### 10. Aliana Development

**APPLICANT:** LJA Engineering and Surveying, Inc.

**PROPOSAL:** A) To delete the proposed Westmoor major thoroughfare south of the proposed West Airport Boulevard, B) To add West Airport Boulevard as a major thoroughfare from FM 1464 to the Grand Parkway, and C) To realign West Bellfort from Mortin west of Harlem eastward to Gaines Road.

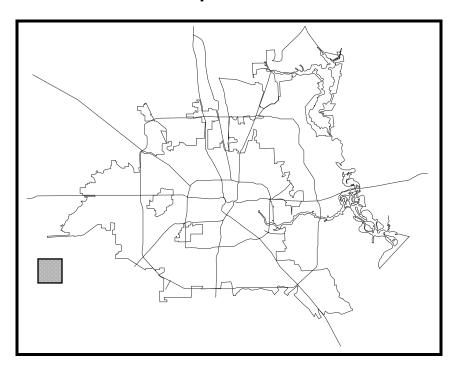
**STAFF RECOMMENDATION:** To approve the three proposed changes to the Major Thoroughfare and Freeway Plan. A) DELETION of Westmoor south of the proposed West Airport Boulevard, B) ADDITION of West Airport Boulevard from FM 1464 to the Grand Parkway, and C) REALIGNMENT of West Bellfort from Mortin west of Harlem eastward to Gaines Road.

**JUSTIFICATION:** The location of the Grand Parkway forms the western boundary of this development and due to the its limited access design, an interchange with proposed Westmoor is not being permitted. However, an interchange with W. Airport has been included in the Grand

Parkway design and will service the area with ccess to the Grand Parkway. Realignment of W. Bellfort is desirable in the avoidance of an existing sand pit and other existing uses.

**PC ACTION:** To approve the three proposed changes to the Major Thoroughfare and Freeway Plan. A) DELETION of Westmoor south of the proposed West Airport Boulevard, B) ADDITION of West Airport Boulevard from FM 1464 to the Grand Parkway, and C) REALIGNMENT of West Bellfort from Mortin west of Harlem eastward to Gaines Road.
